A47 Wansford to Sutton Dualling

Scheme Number: TR010039

Appendix 13.2 – Drainage strategy report

ENVIRONMENTAL STATEMENT APPENDICES
Appendix 13.2 – Drainage Strategy Report

Sheet 5

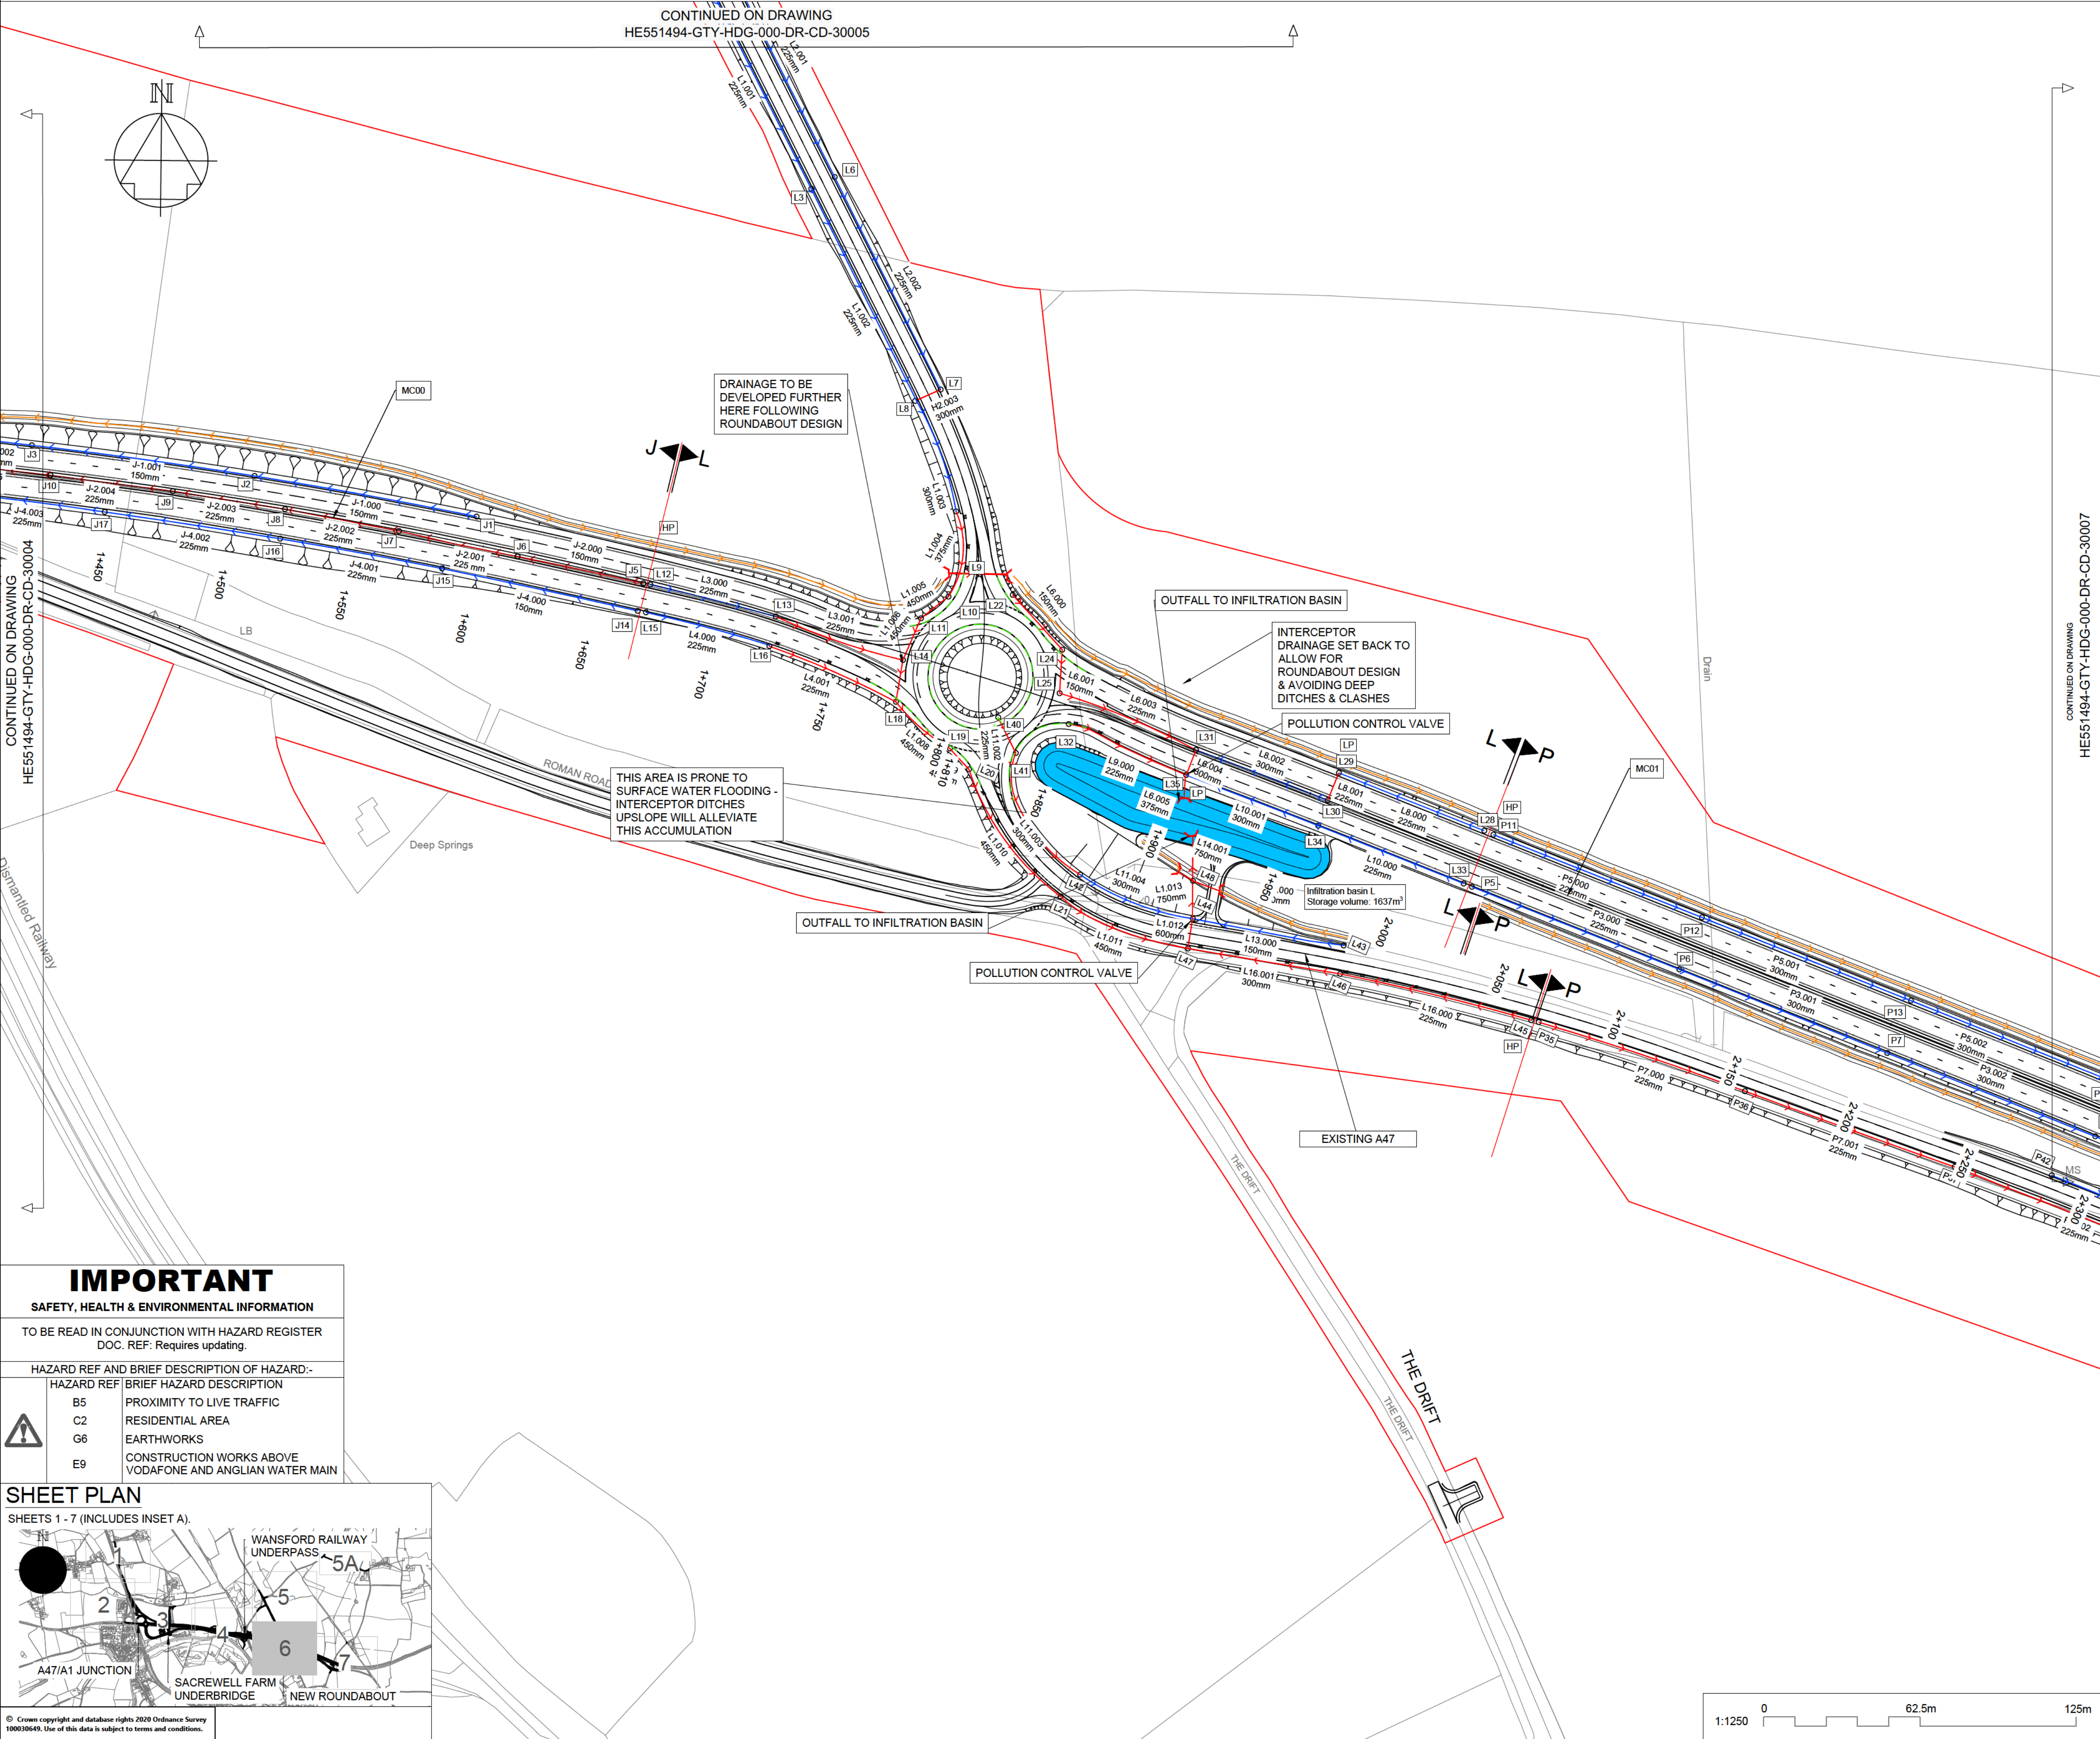
1. Network M - In relation to the proposed outfall at manhole M21, as we understand it this existing drain is in a poor condition / now non-existent due to cattle occupying the adjacent field. As such we would be cautious of a positive system discharging into said ditch. As stated on the drawing a drainage survey will be required.
2. Network N - In relation to the proposed outfall at manhole N4, a drainage survey is required as we are not aware of any existing positive drainage system on Sutton Heath Road.

Sheet 6

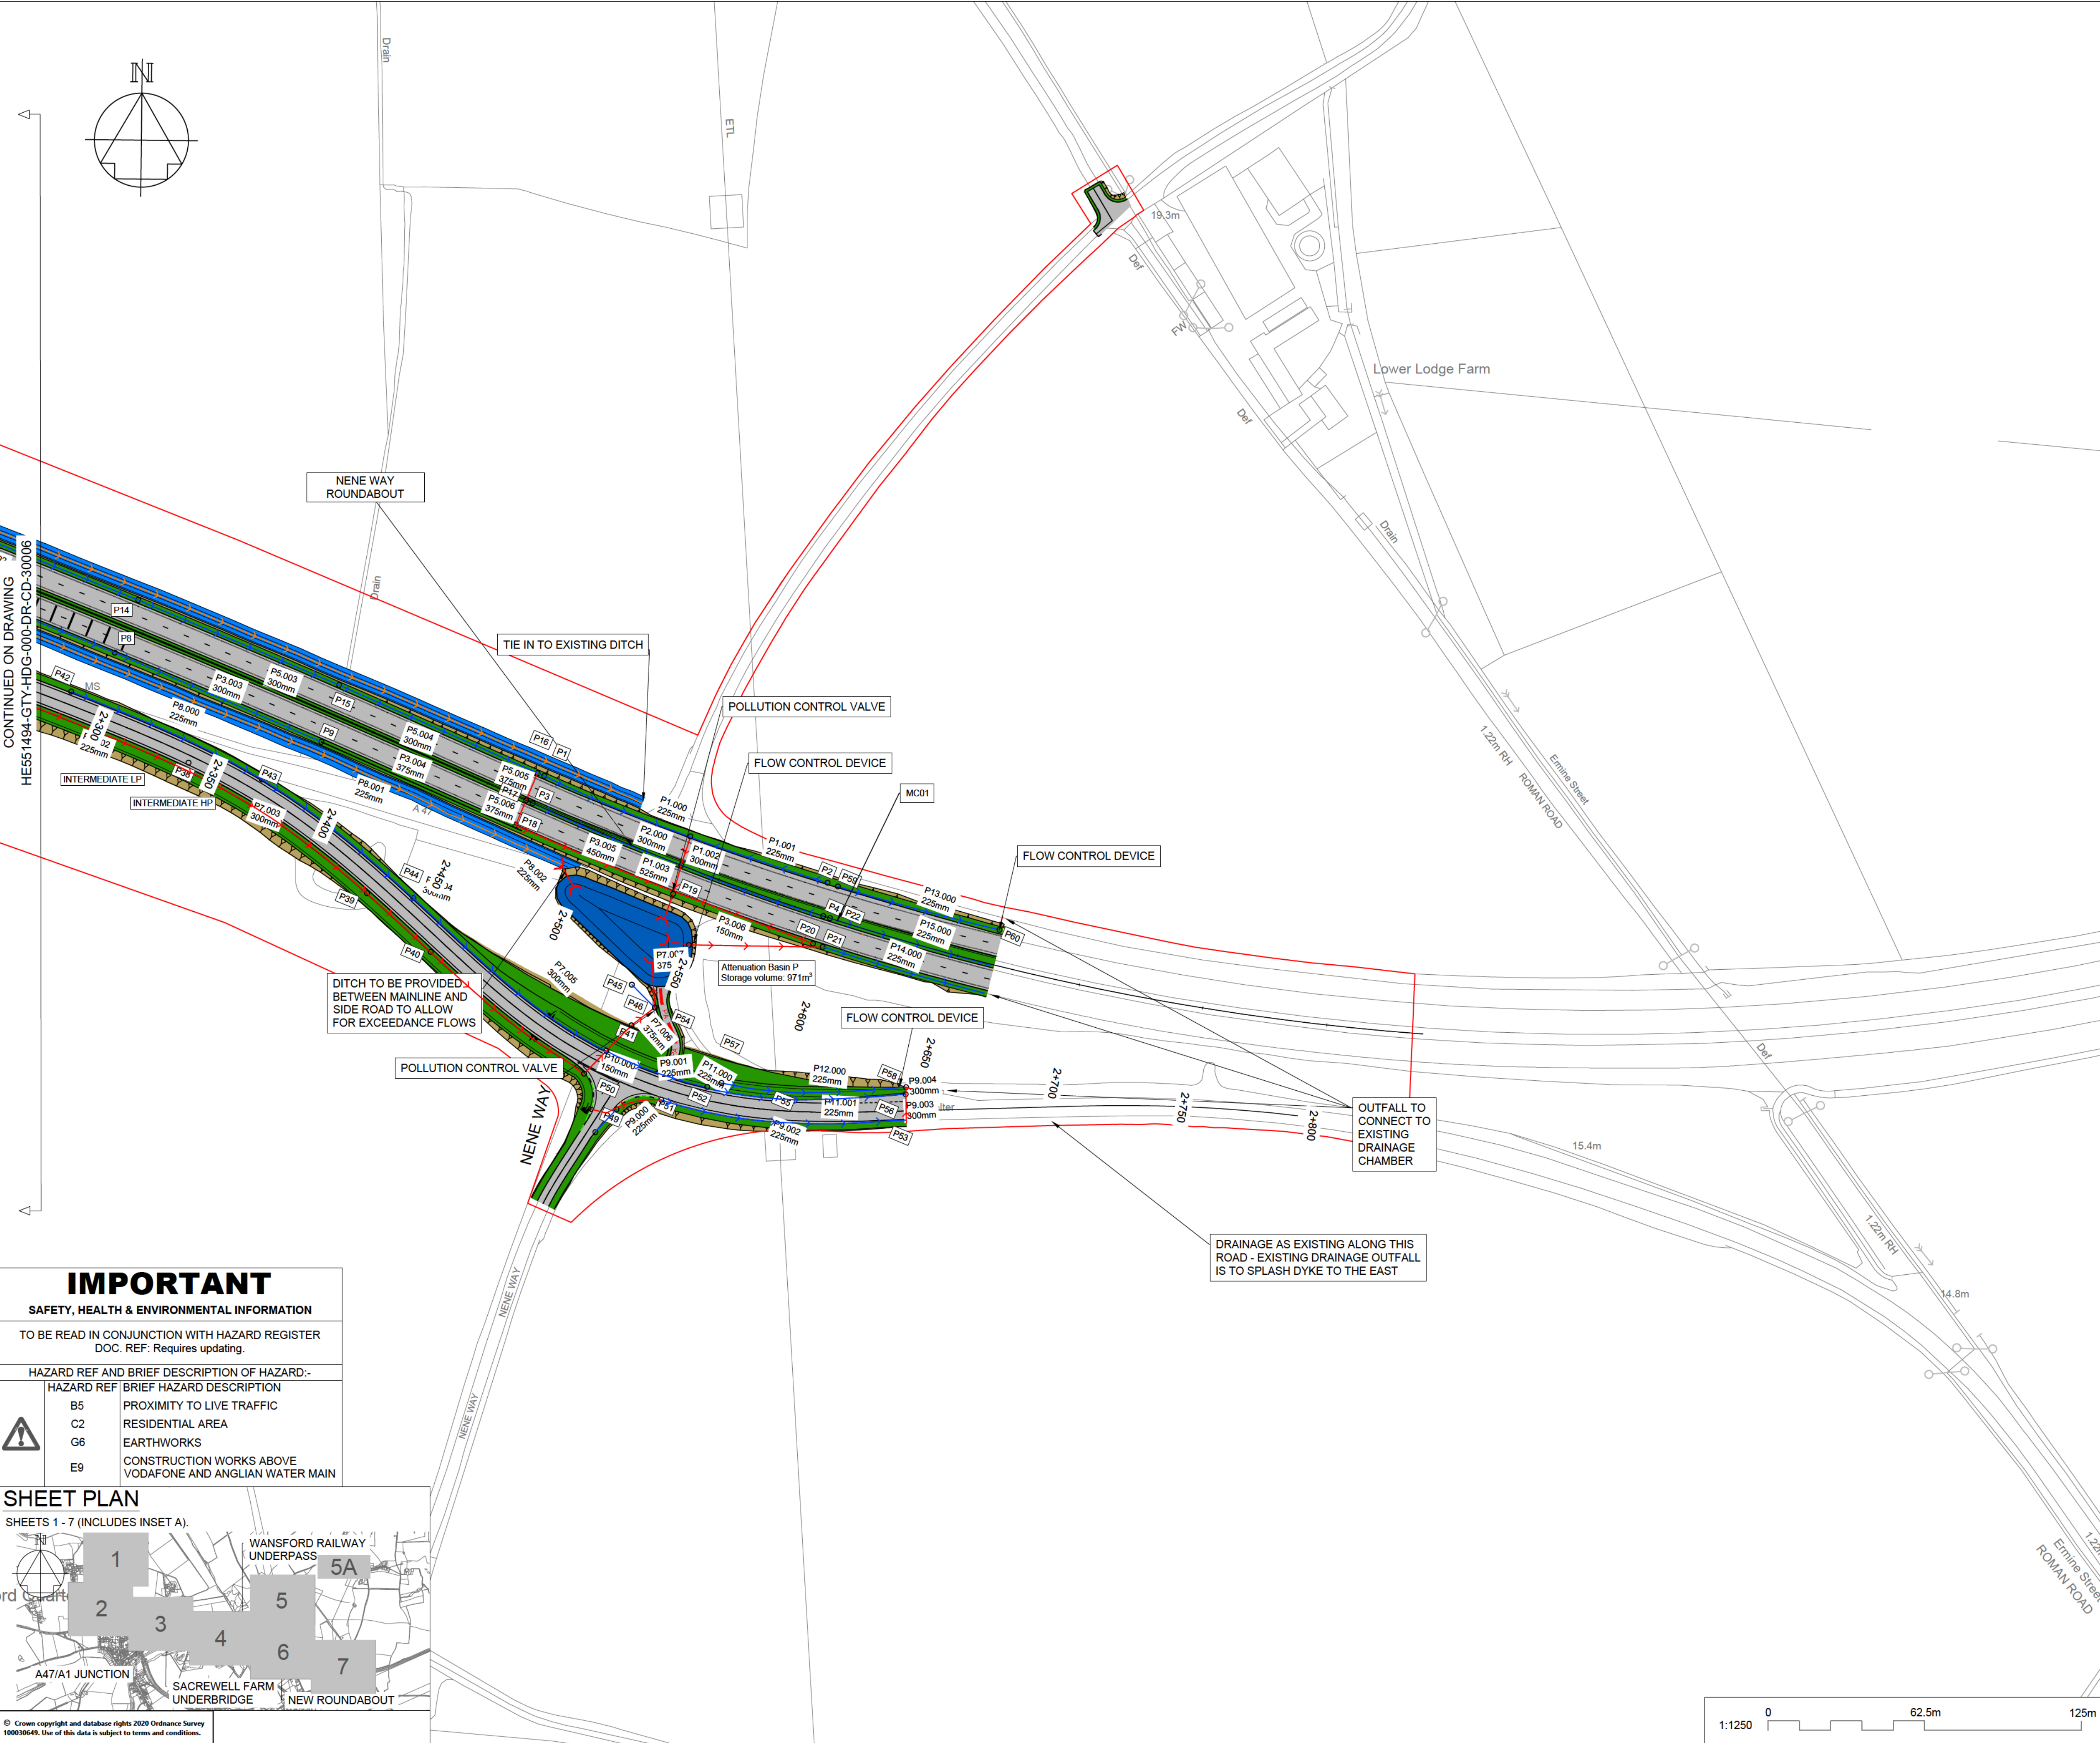
1. Infiltration basin L - ground investigation information and infiltration test results need to be provided, which should also include the levels of the water table.
2. In relation to the proposed new road north of the roundabout and the associated culvert, if these were intended to be offered for adoption to the Local Highways Authority, then we would recommend that you get in touch with the PCC's Highway Control team regarding this.
3. Network P - we note the drawing references a connection into S11 or to continue along side road, as such we require clarification of what this refers to.
